ZONING CHANGE REVIEW SHEET

CASE: C814-86-023.03 – Camelback PUD Amendment #3

ZONING FROM / TO: PUD, to amend a previously approved land use plan, allowable uses, site development regulations, and request modifications to cut and fill requirements.

The Staff recommendation is to grant the third amendment to planned unit development (PUD) district zoning, as shown in the Proposed PUD Amendment summary on pages 3-4 of this report and as referenced in the replacement Exhibits C, D1, D2, E, and G.

**CAMELBACK PLANNED UNIT DEVELOPMENT
PUD LAND USE PLAN
DECEMBER 17, 2024**

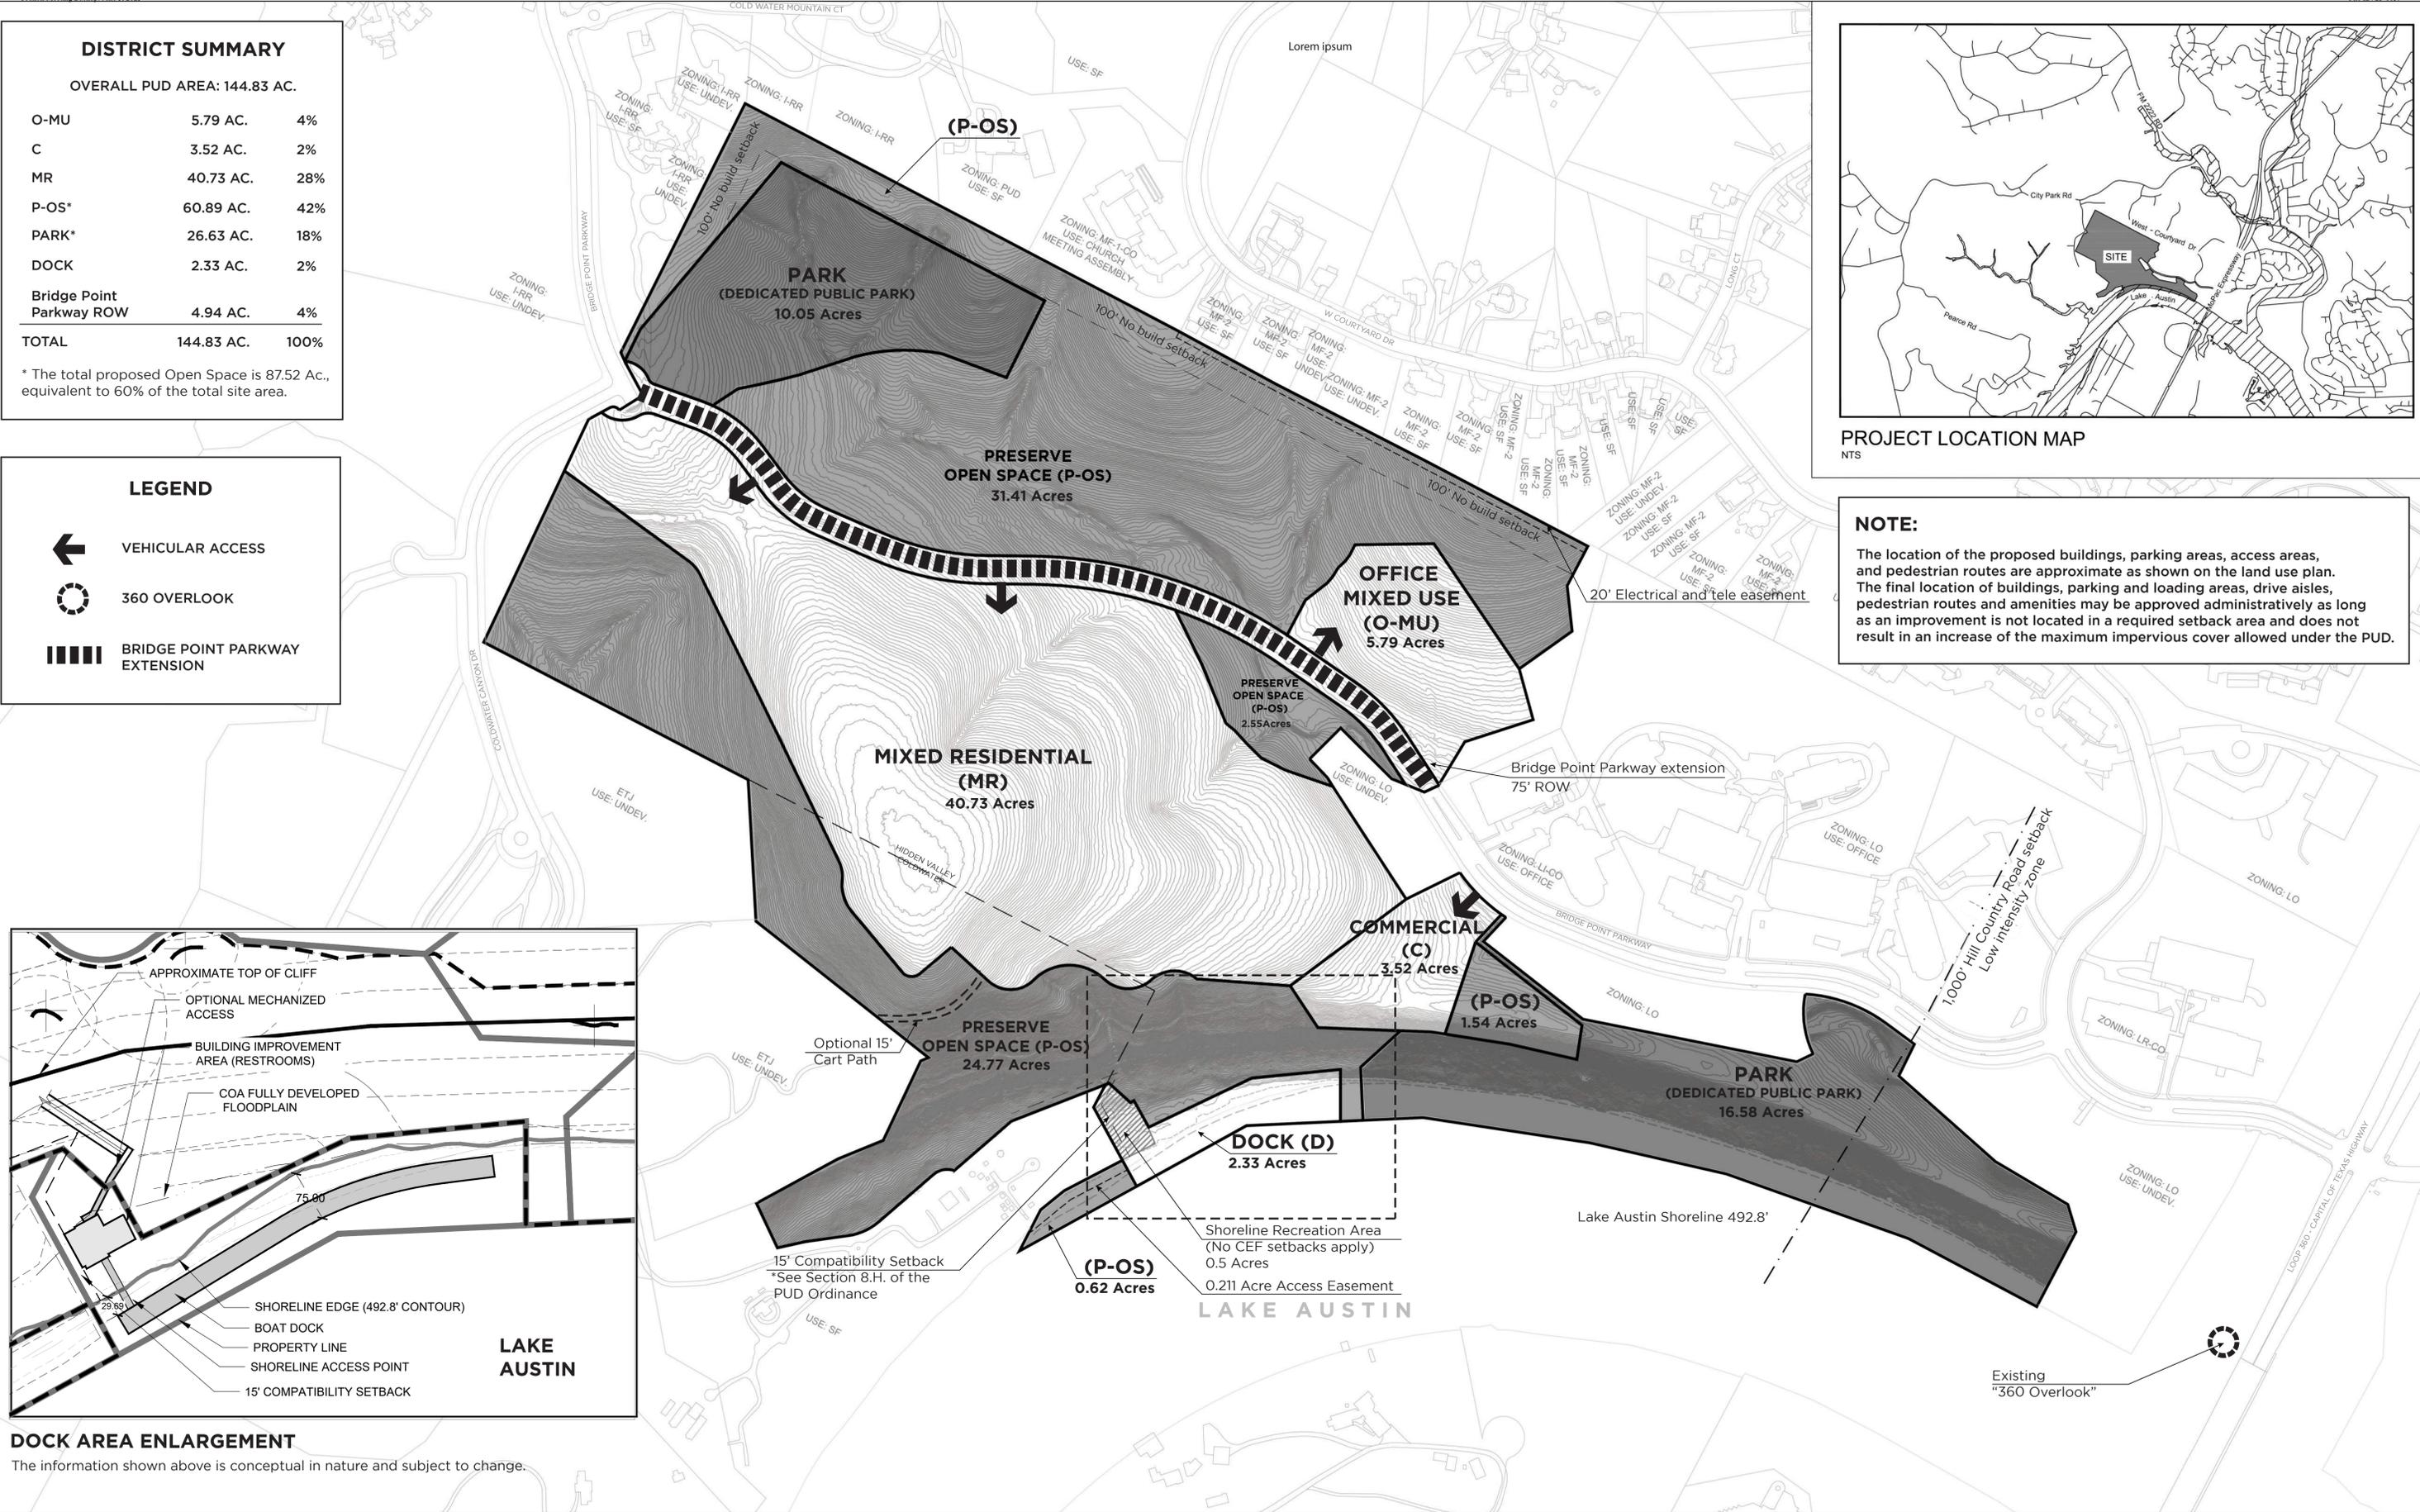
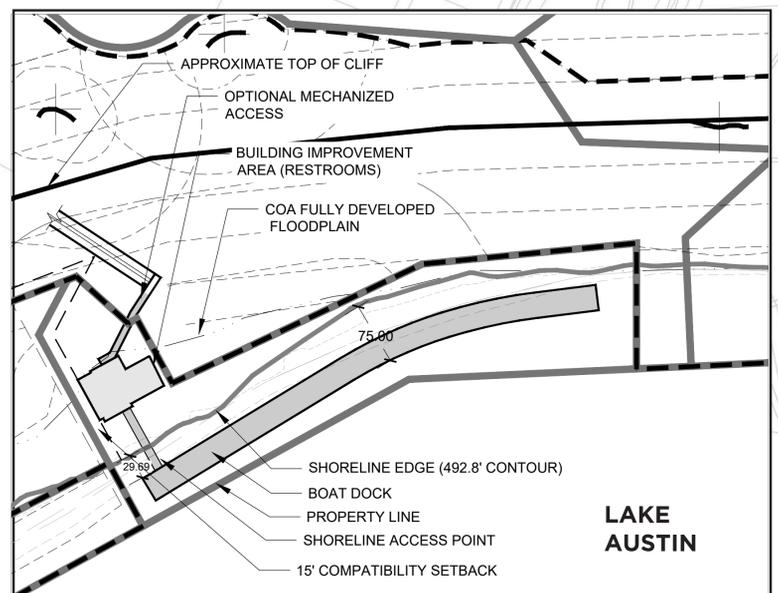
The applicant is requesting an amendment to the Camelback PUD. The significant revision being proposed to the Land Use Plan is to provide an option for a Cart Path and Off-site Surface Access in lieu of the funicular (mechanized access) to reach the Dock (D) District. The 15-foot-wide cart path would run from the Mixed Residential (MR) District, across the Preserve Open Space (P-OS), to a connecting point on the adjacent property to the south as depicted on the proposed PUD Land Use Plan. ***Please refer to Exhibit C.*** Since the cart path would run along the natural topography of the land, it will minimize visual impact to the hillside.

Exhibits C and G will be amended to provide an option for a Cart Path and Off-site Surface Access to the Dock (D) District in lieu of mechanized access.

CAMELBACK PLANNED UNIT DEVELOPMENT PUD NOTES AND EXHIBITS

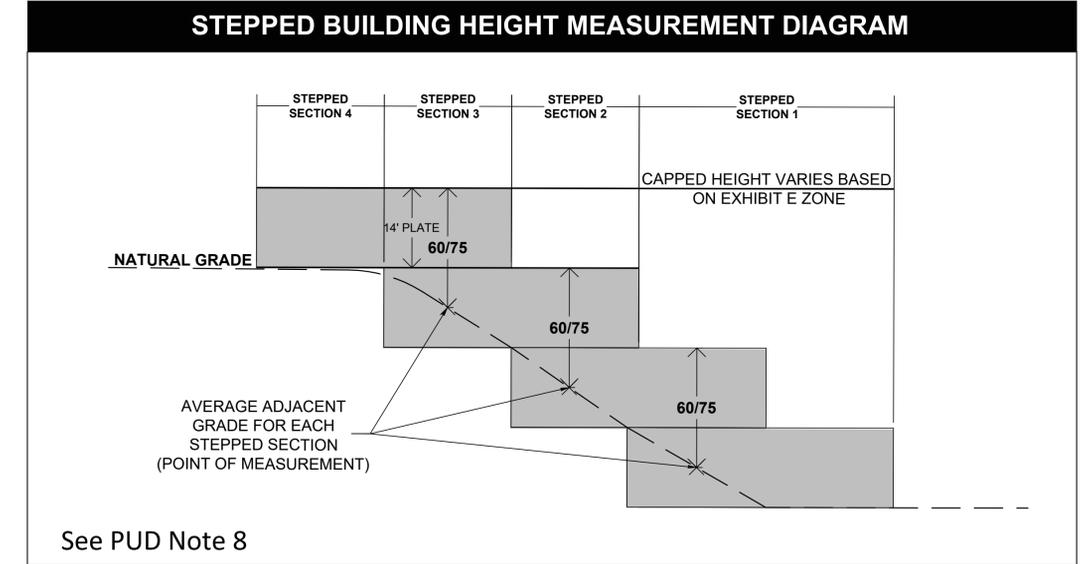
Exhibit D1 will be amended to revise the Land Use table, Cut and Fill table, and the Site Development Regulations table.

Exhibit D2 will be amended to add Note 14 - Offsite access to Lake Austin through the adjacent tract, including fire access and utility extensions, is preferred over the funicular access. City will work with Landowner to facilitate offsite access subject to appropriate review and approval.

5. **Amend the Cut and Fill Table on Exhibit D2 to increase the allowable cut and fill for the project.** The Applicant proposes this change to address current market conditions and project planning.

**CAMELBACK PLANNED UNIT DEVELOPMENT
PUD ENVIRONMENTAL RESOURCE EXHIBIT
JUNE 06, 2025**

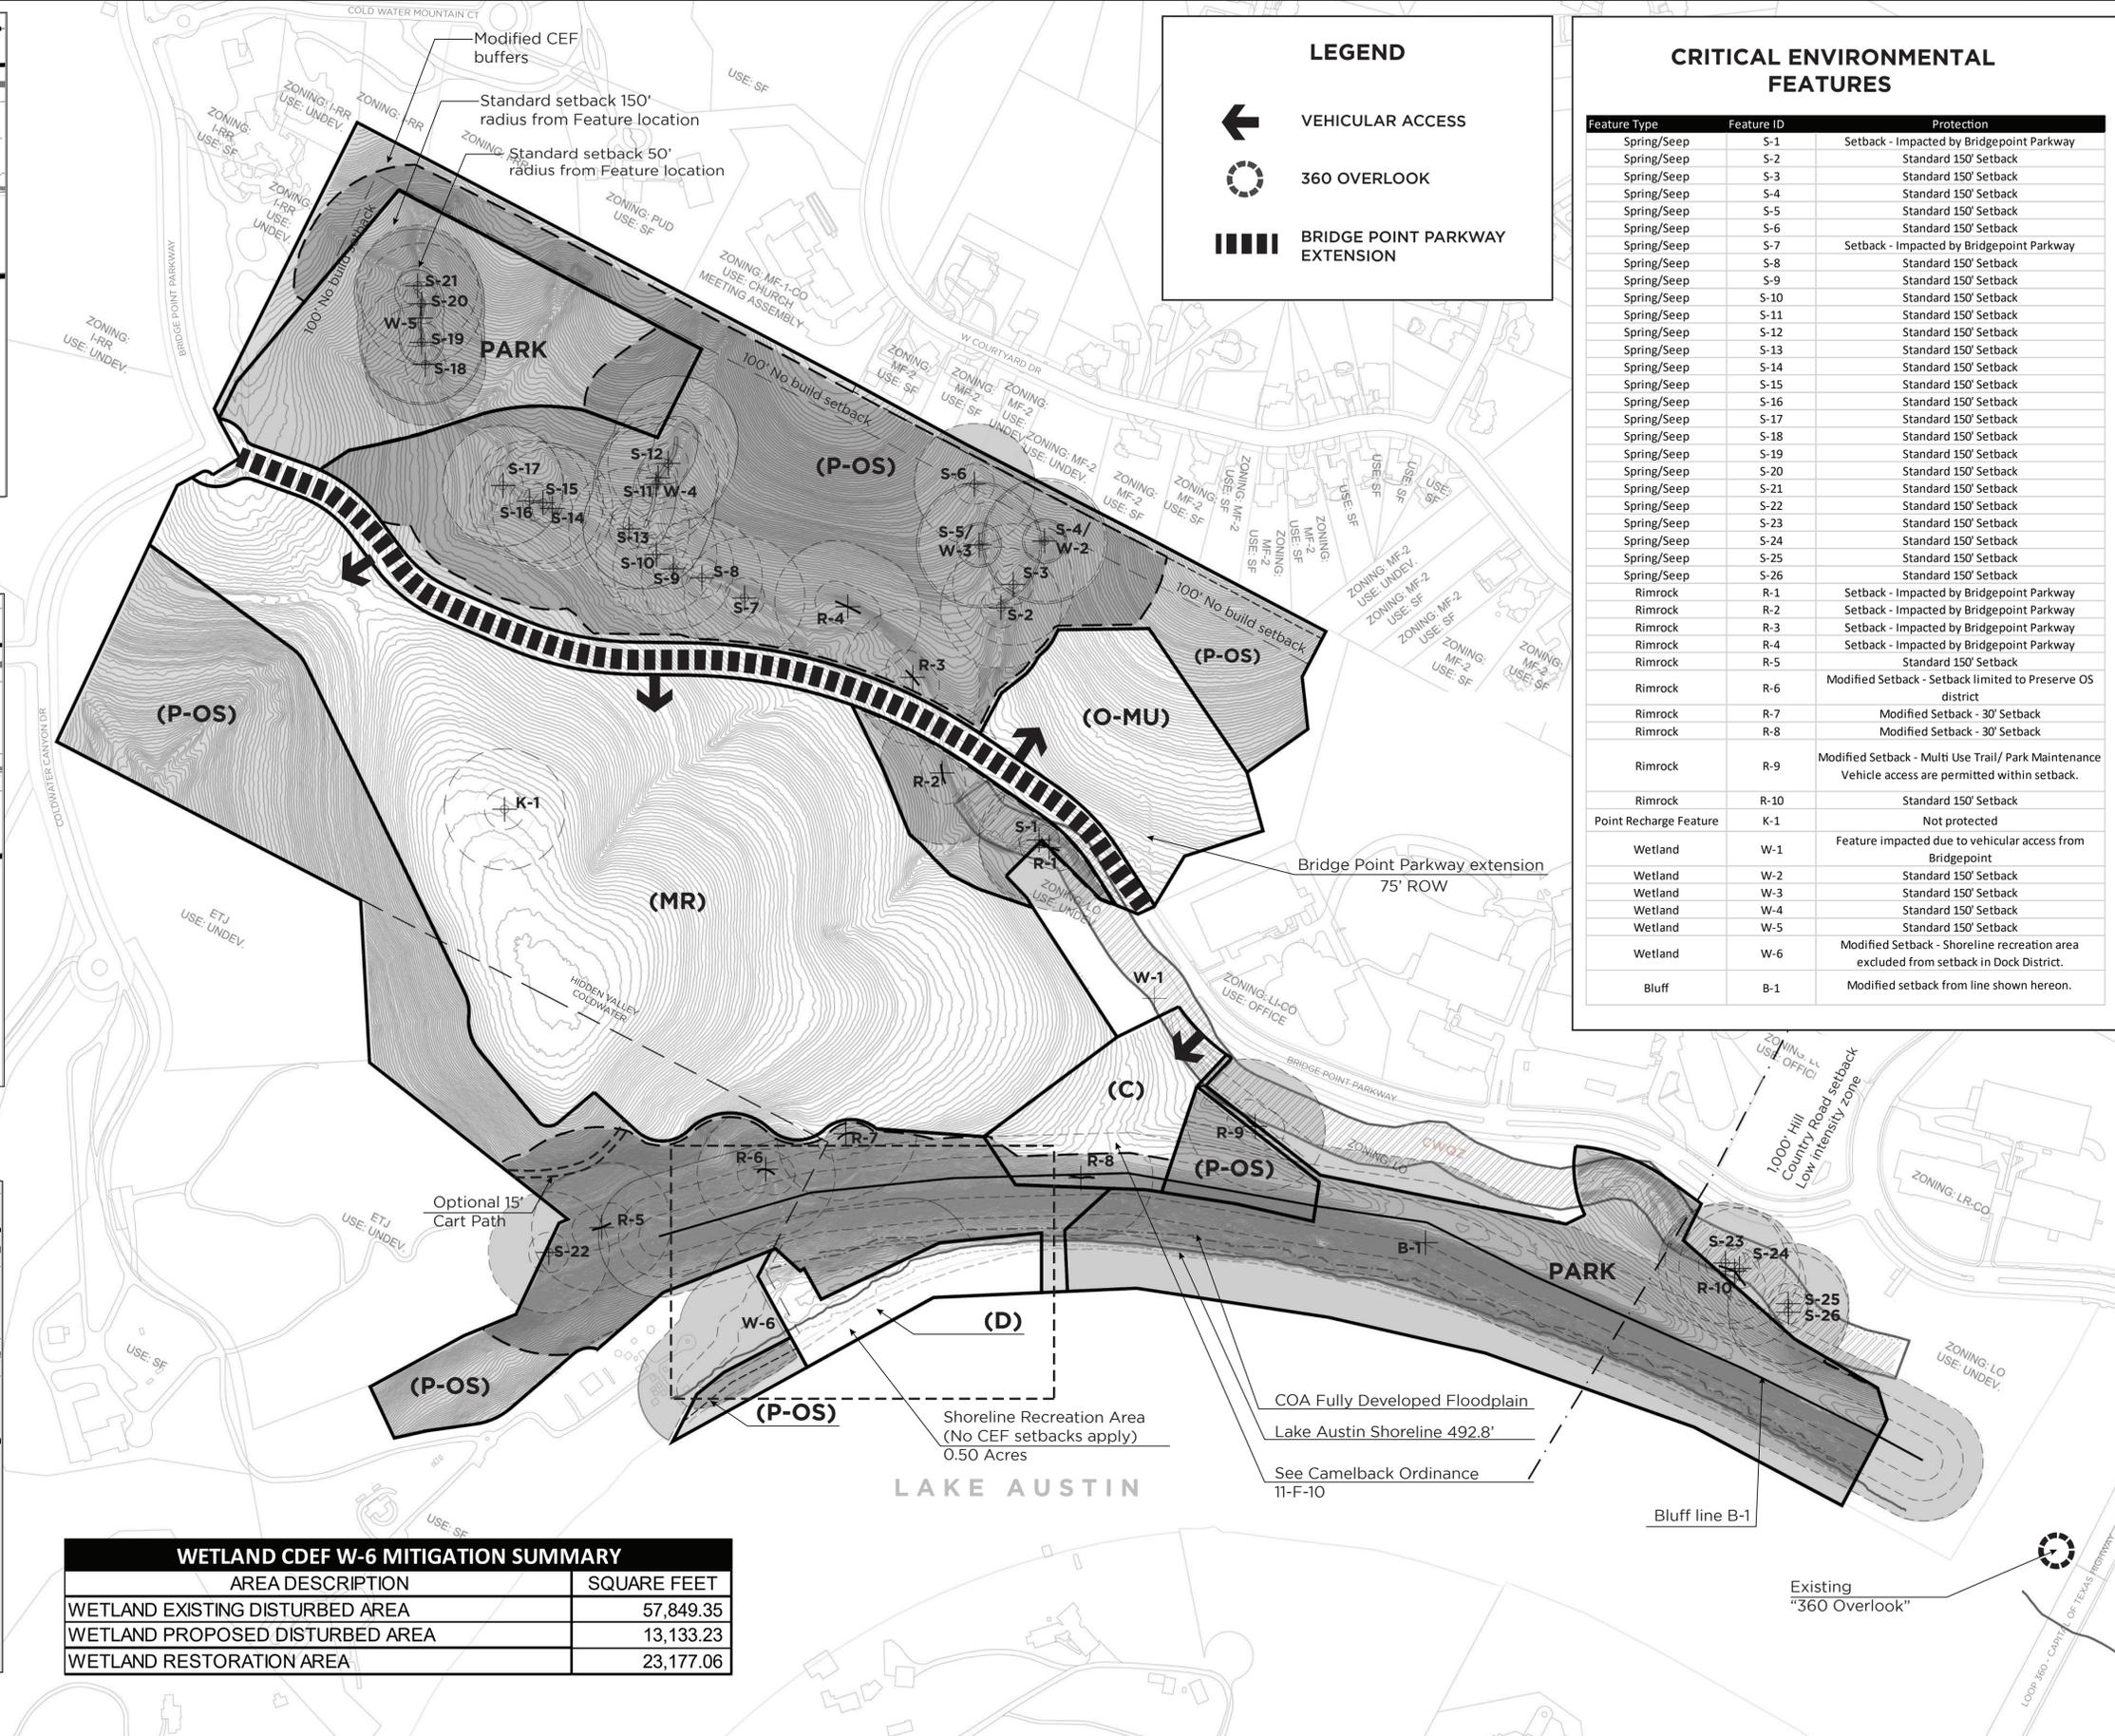
No impacts to CEF/setbacks proposed as part of the cart path. Funicular would significantly impact the rimrock and removal in lieu of cart access is preferred.
Exhibits updated showing required cut/fill for the cart path.
